S4.55 CHANGES

CLIENT: ANGLICARE CASTLE HILL
ADDRESS: 284 CASTLE HILL RD, CASTLE HILL NSW 2154
DRAWING: EXISTING & DEMOLITION PLAN WEST

PROJECT
201656 WESTERN ROAD

DRAWING
ROOF PLAN - BUILDINGS 8 AND 9B

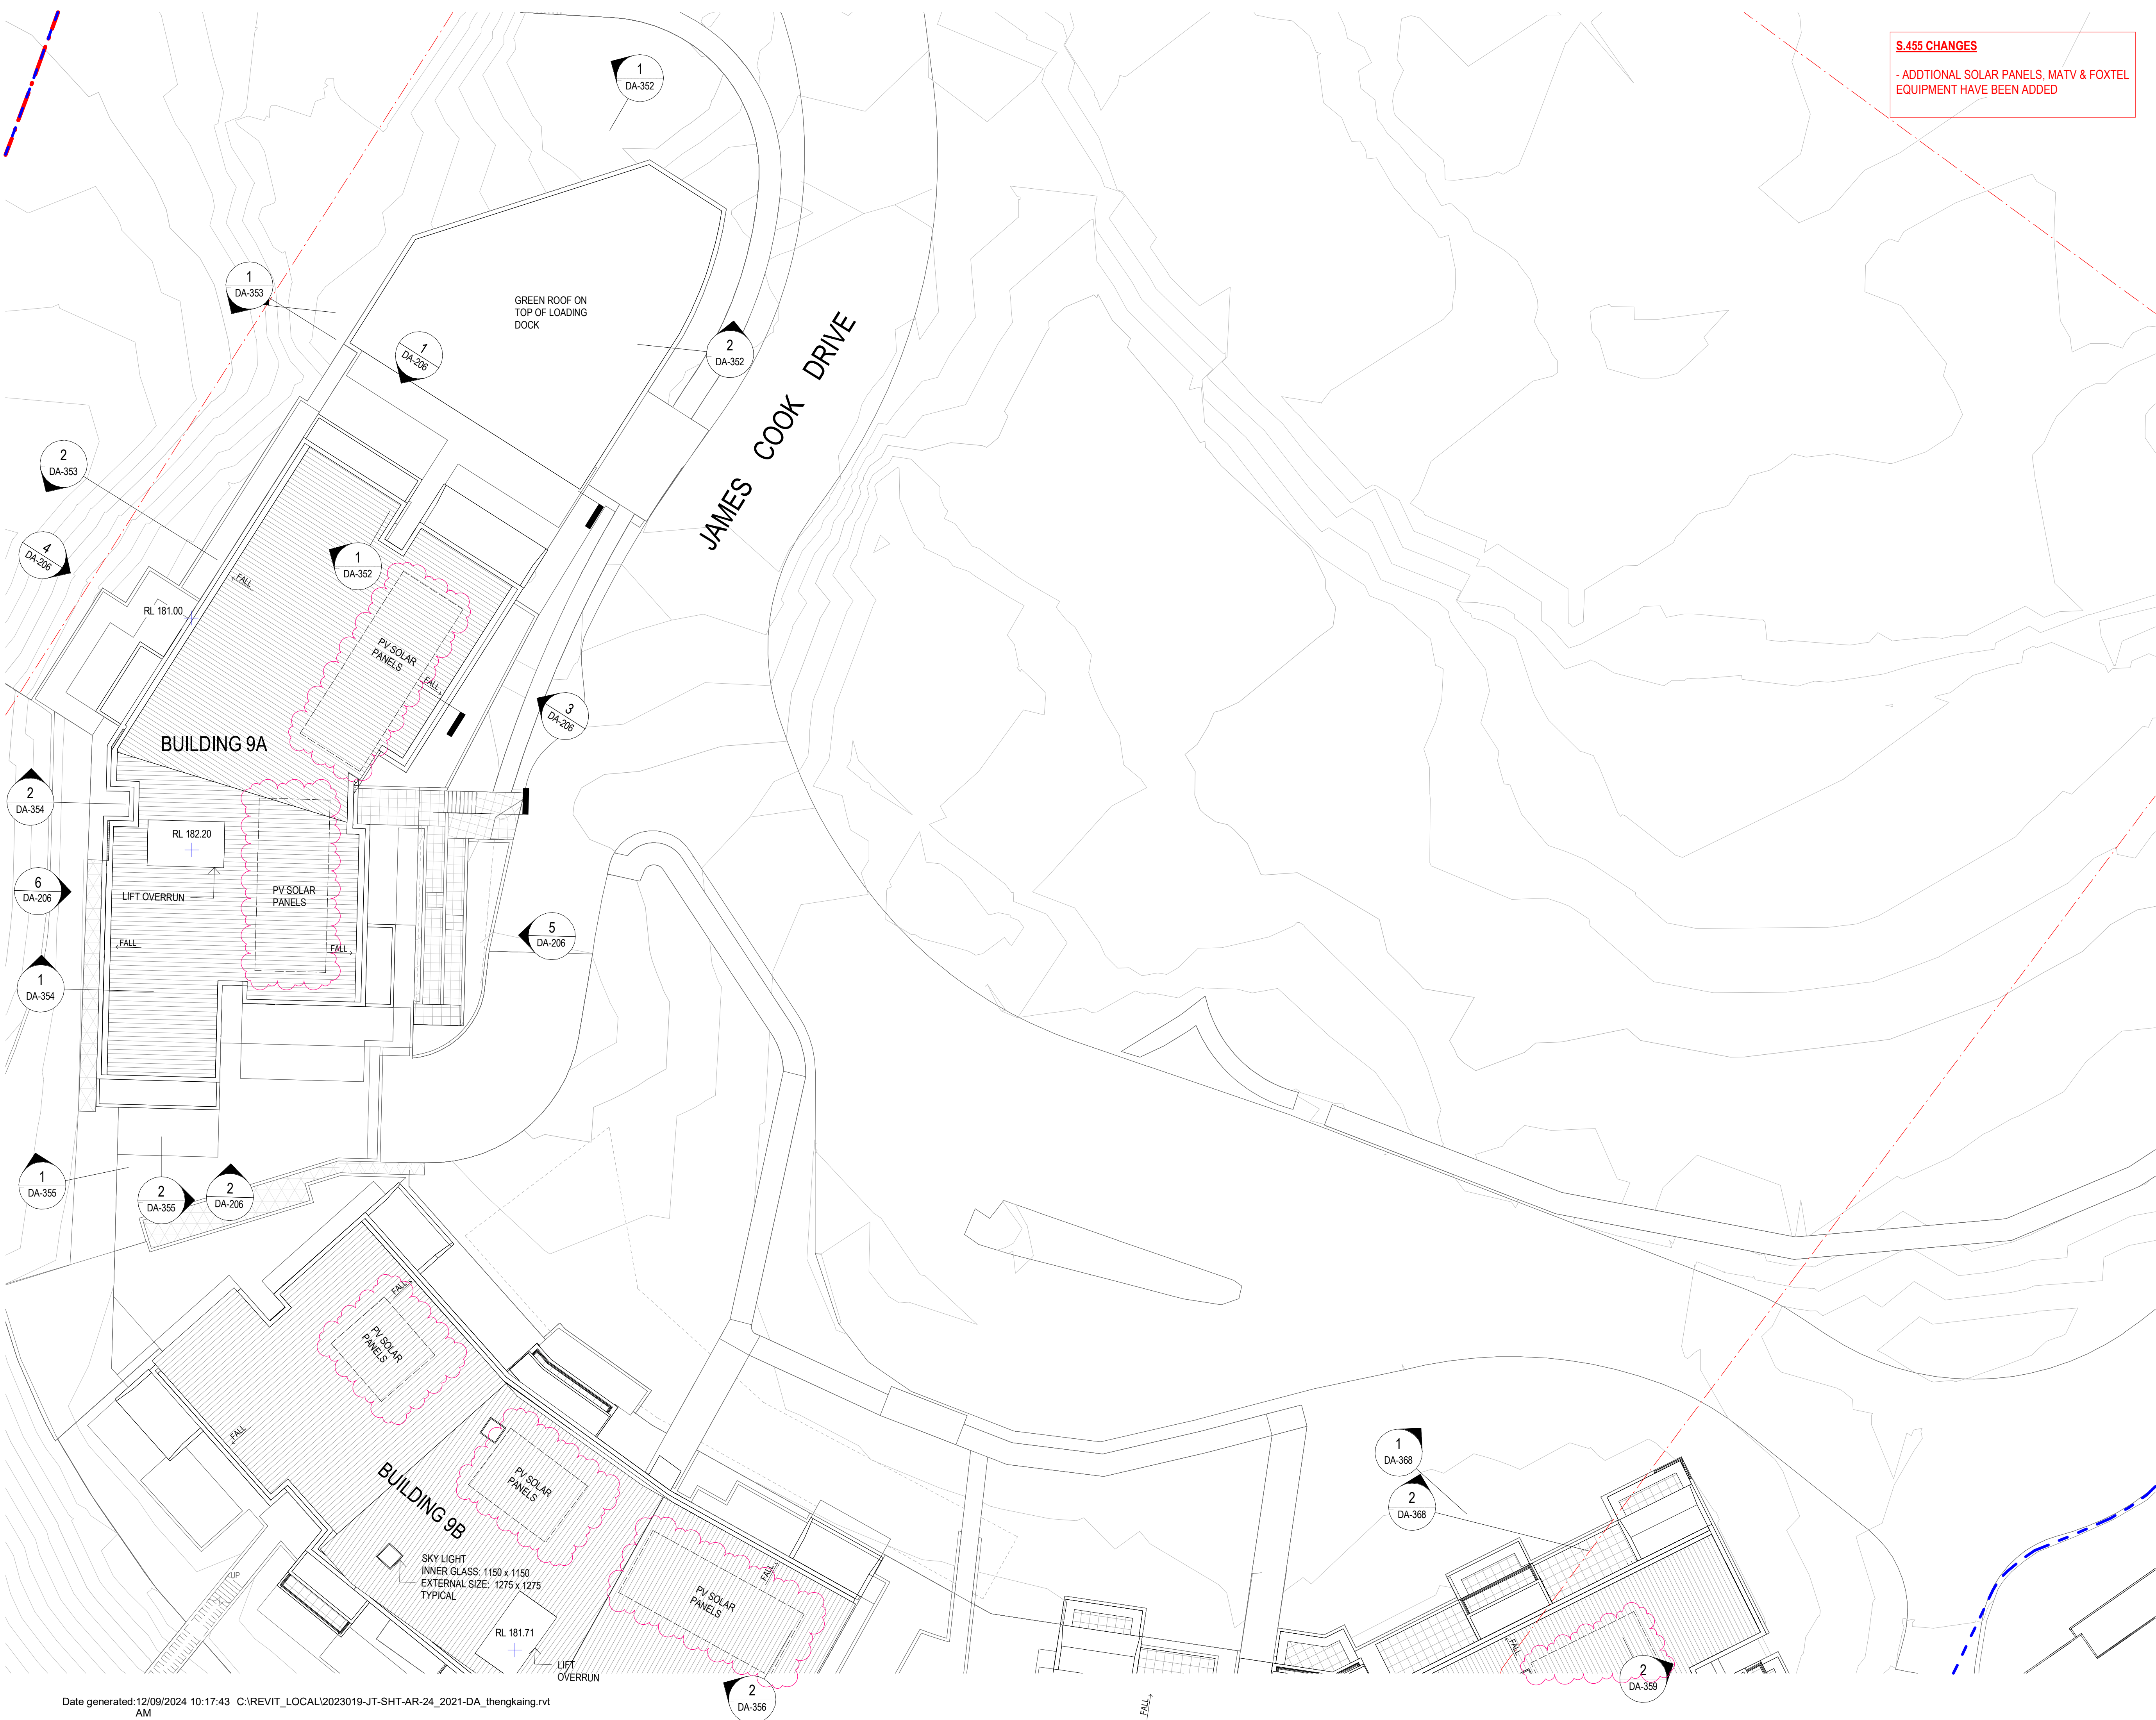
- ADDITIONAL SOLAR PANELS, MATV & FOXTEL EQUIPMENT HAVE BEEN ADDED
